# TECH Information

Importer : Quadpower

Object: : adjust of new bumper

- **Adjust the Clearance of Front Bumper**

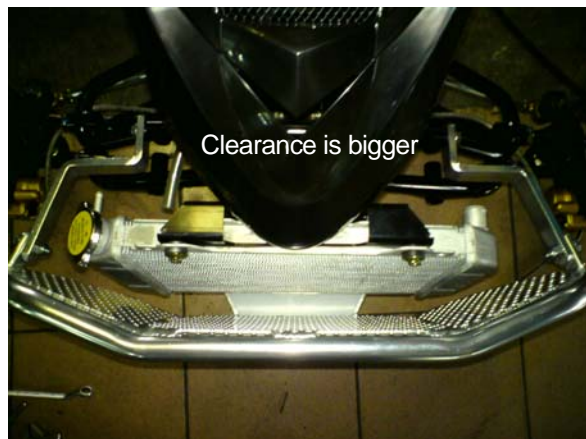
The above two pictures show the different clearance between radiator and front bumper.

The Left picture, clearance is smaller and can be adjusted by following process. Due to the front bumper doesn't install on bike when we delivery to you. Therefore, once you find the clearance is too small when you install it on, please kindly follow the suggestion and adjust.

Step1, Take off bolt of radiator

Step 2, Take off spacer of radiator

## Step 3, change rubber position
